BAGHDAD RAILWAY STATION
REHABILITATION
BAGHDAD, IRAQ

SIGIR PA-06-057
JULY 25, 2006

SUBJECT: Report on Project Assessment of the Baghdad Railway Station
Rehabilitation, Baghdad, Iraq (Report Number SIGIR-PA-06-057)

Site Photo 20. One of two electrical sewage pumps in the pump house

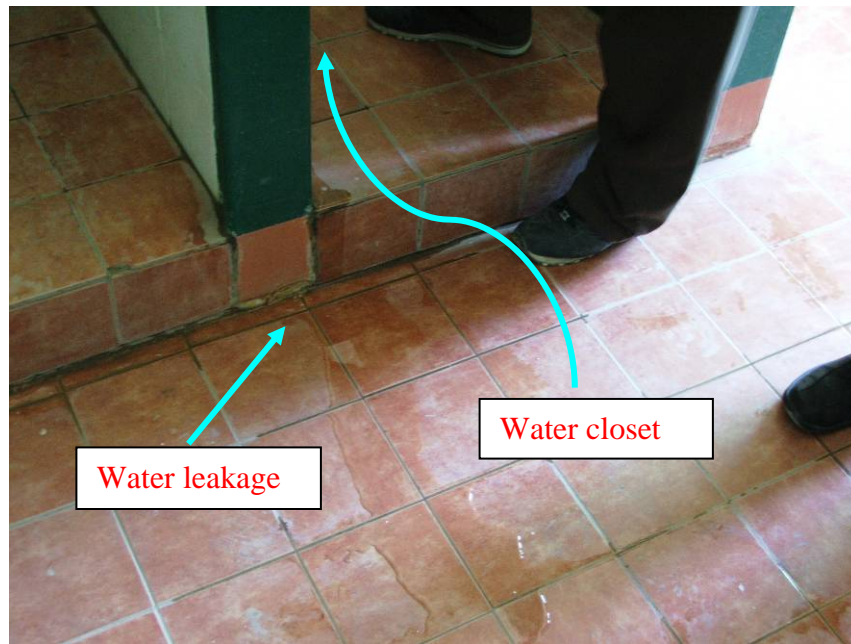
The design required two new sewage station pumps (flow (Q) = 20 m³/hr at 6 m head) in each of the two lift stations. However, the BOQ listed a requirement for sewage pumps with a capacity of 12 m³/hr. We inspected one of the two sewage pump houses (Site Photo 19) and verified two electrical sewage pumps were in place and operating (Site Photo 20). Discussions with the DRE, and a review of catalog cut information indicated the pump capacity at Q = 17 m³/hr at 10 m head.

The IRR has issues with the pumps as noted in a letter to the contractor dated 14 June 2006, indicating the pumps (item 2) need to be heavy duty. The contractor responded that the pumps comply with the submittal requirements that had been approved by the IRR.

At the time of the assessment, the issue had not been resolved, but the DRE, PCO, and representatives of IRMO were meeting to address punch list items, pending modification work, and the issues raised in the contractor's letter.
